Agenda
City of Springboro Planning Commission Meeting
Wednesday, September 13, 2023, 6:00 p.m.
Council Chambers, City Building, 320 West Central Avenue

Background Information & Staff Comments/Recommendations
City of Springboro Planning Commission Meeting
Wednesday, September 13, 2023, 6:00 p.m.
Council Chambers, City Building, 320 West Central Avenue

Final Development Plan, Village Park PUD-MU, Planned Unit Development-Mixed Use, 748 Gardner Road, retail development

- D. Preliminary Review, Rezoning, R-1, Estate-Type Residential District, to PUD-R, Planned Unit Development-Residential, 1525 South Main Street (SR 741), proposed single-family residential subdivision**
- E. Preliminary Review, General Plan, R-1, Estate-Type Residential District, to PUD-R, Planned Unit Development-Residential, 1525 South Main Street (SR 741), proposed single-family residential subdivision**

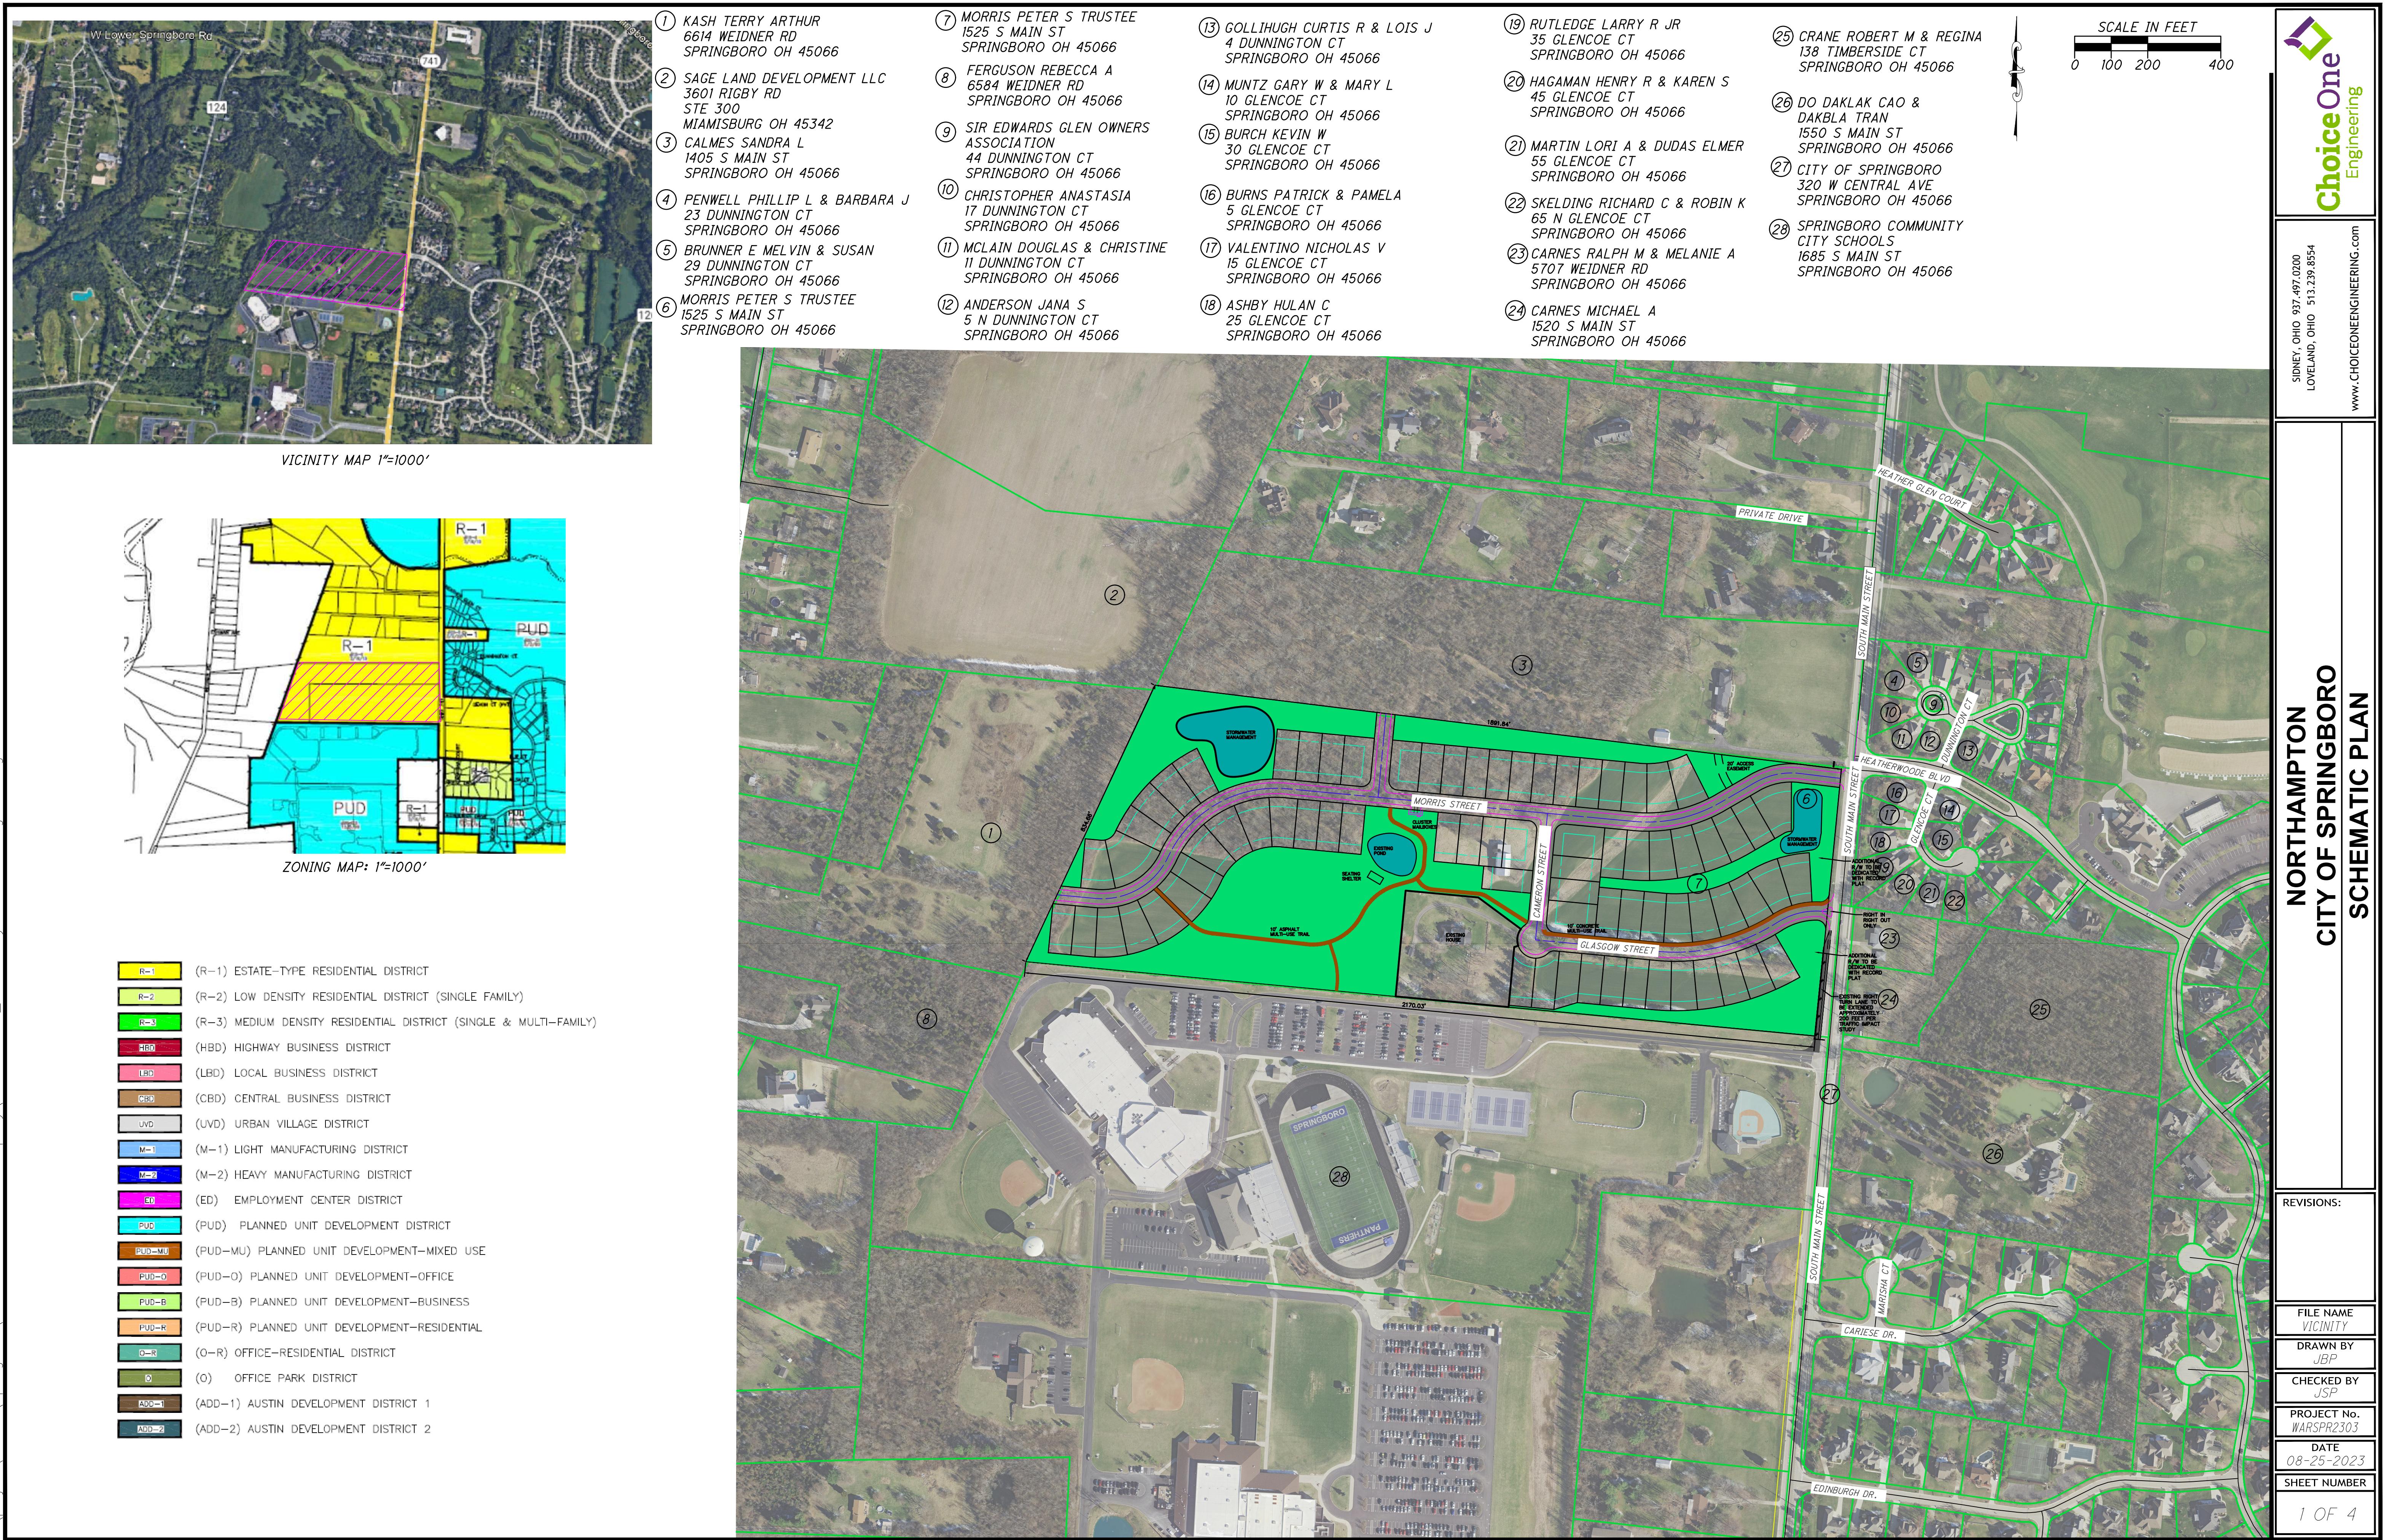
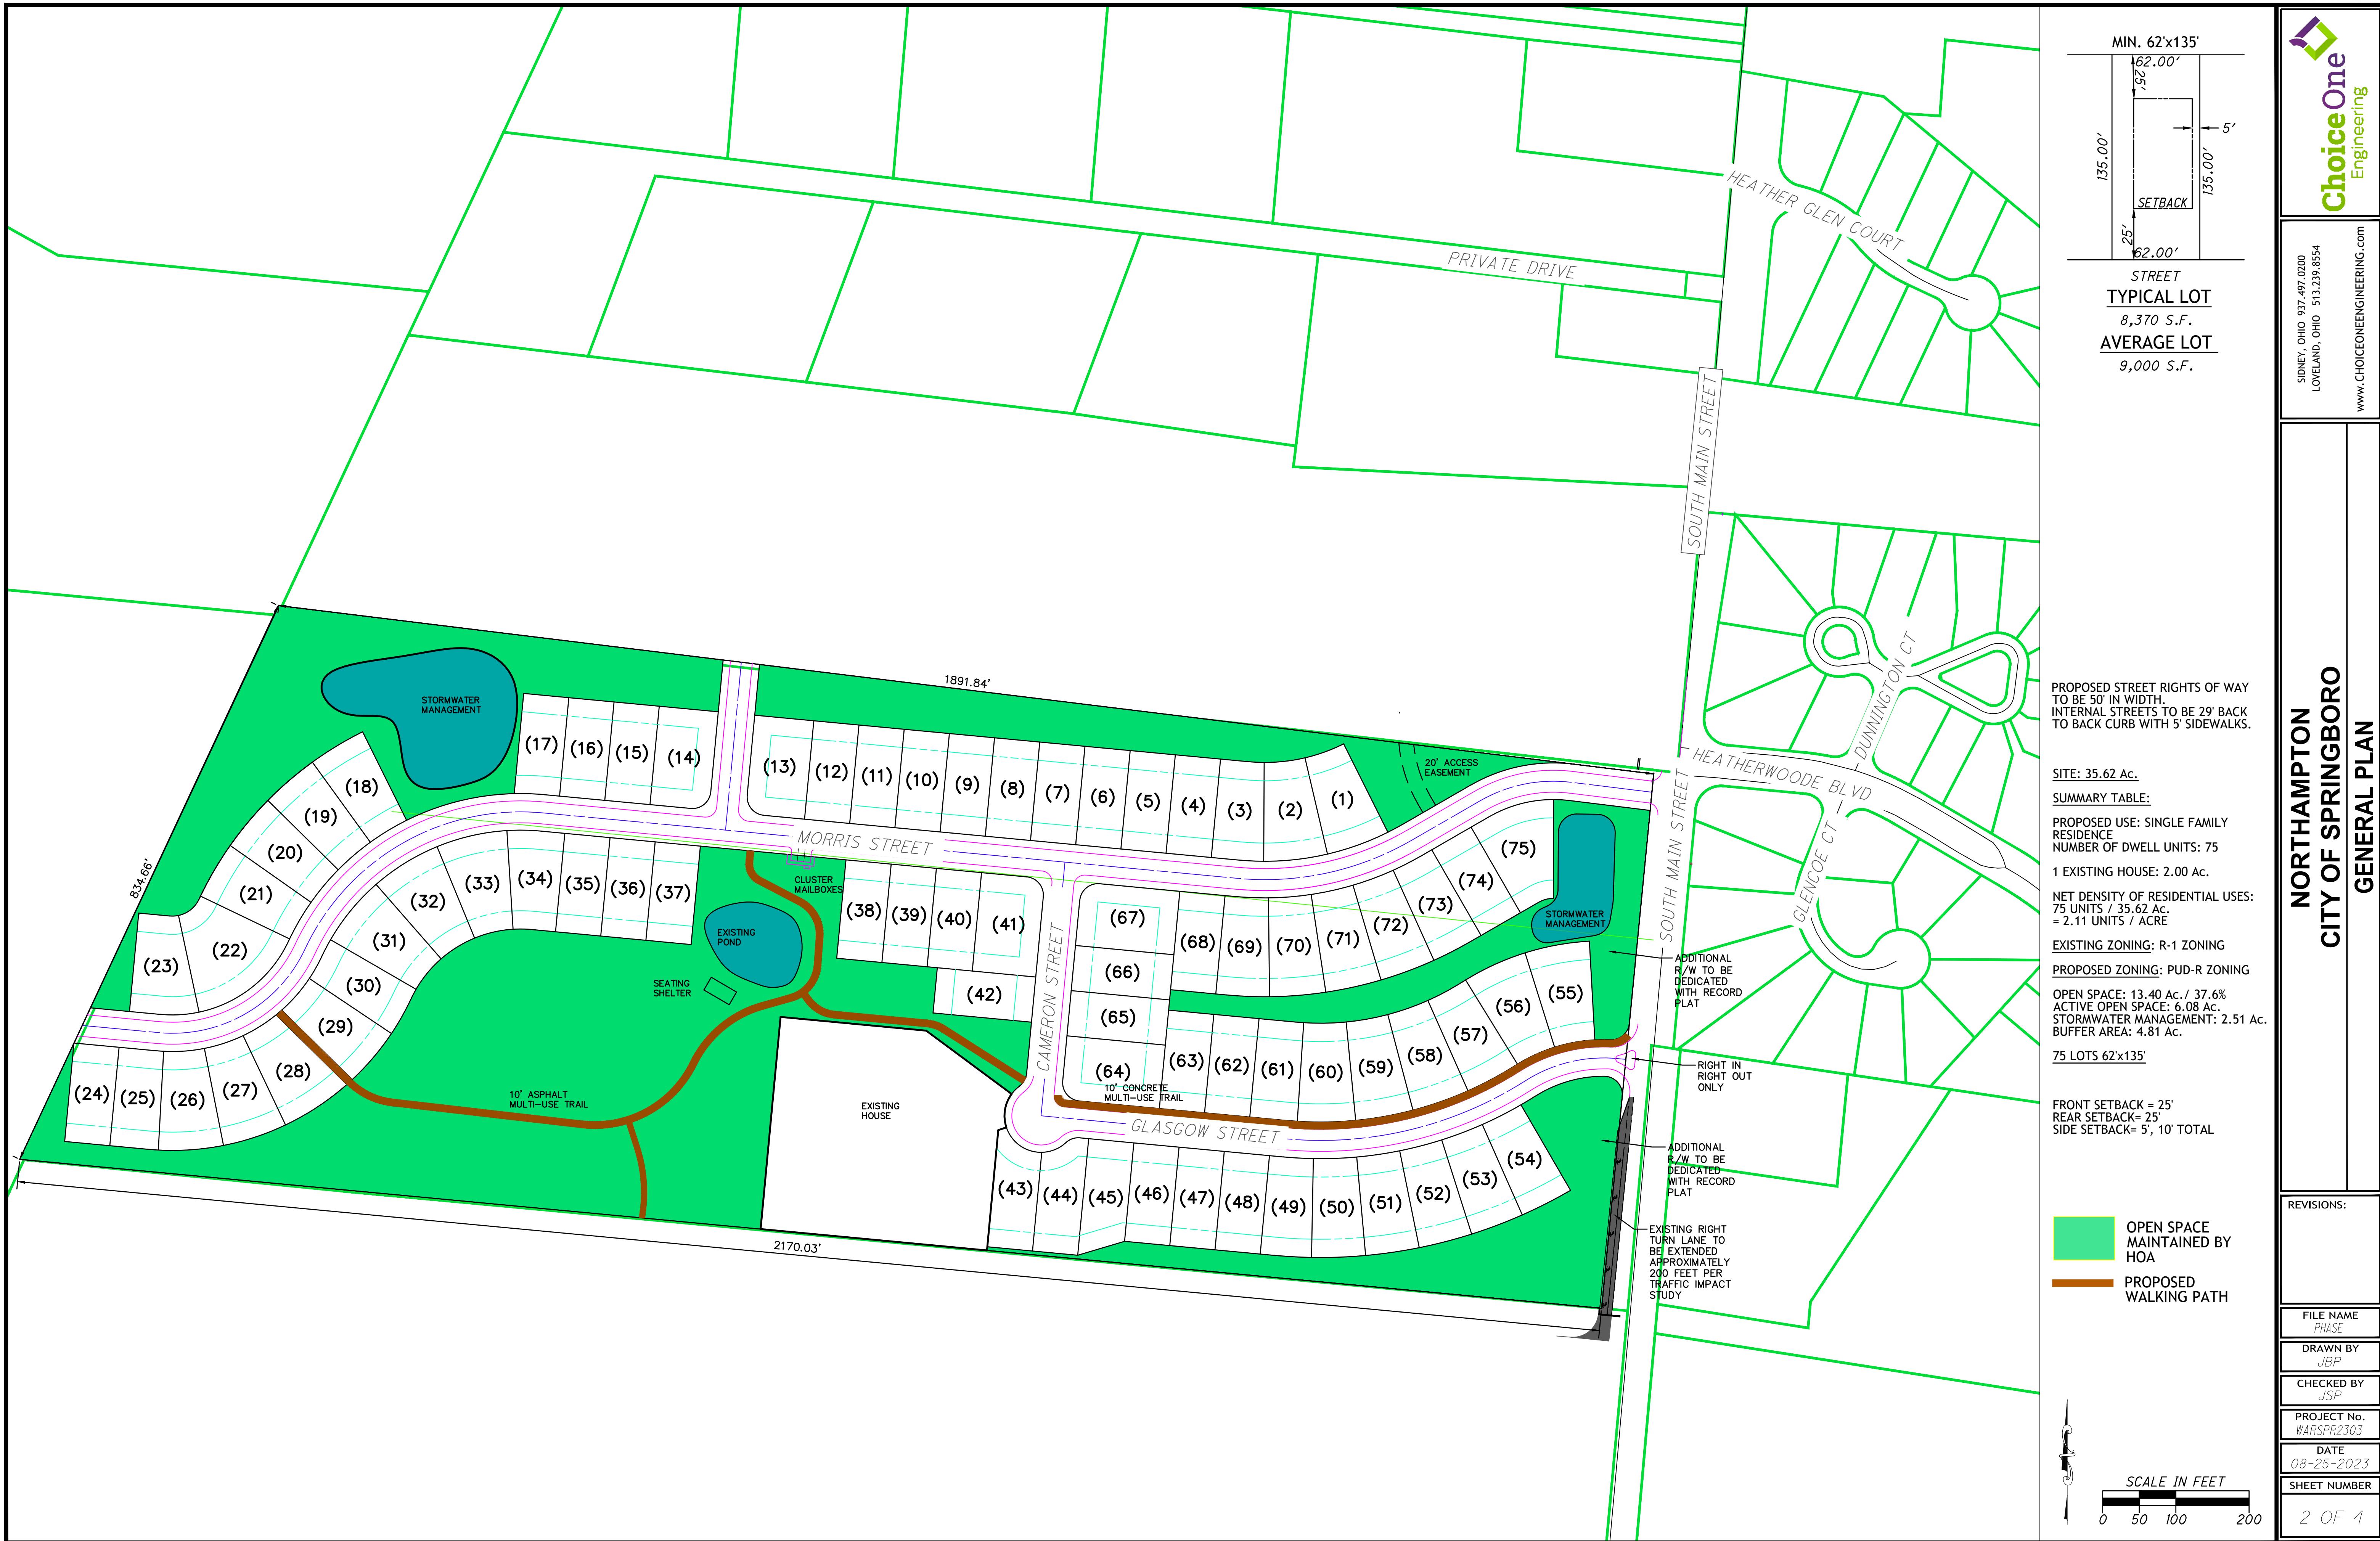
1. What is warranting a development density at the high range for the surrounding area as recommended in Master Plan Policy Area 16 (2.11 dwelling units proposed, three nearby subdivisions developed at 1.72 to 2.10 units/acre)?
2. Home plans to comply with Section 1264.06, Design Standards for Single-Family Detached Dwellings, of Planning and Zoning Code.
3. Indicate proposed exterior building materials for the subdivision.
4. What is the proposed breakdown of ranch and two-story homes proposed? A 50/50 split between the two types was discussed at the August 9th meeting.

5. Provide minimum lot sizes for all proposed lots. Note that side yard setbacks are measured from the roof overhang.
6. Indicate percentage of open space that is set aside for storm water detention, that is buffering to adjacent development, and set aside for amenities within the subdivisions.

7. Reorganize the proposed open space plan so that it provides future residents with more quality open space this is contiguous and usable, then drains the property, then buffers neighboring development in that preference order.

8. Plan to incorporate an east-west multiuse trail into the design of the subdivision to connect Heatherwoode on the east with land fronting Weidner Road to the west.
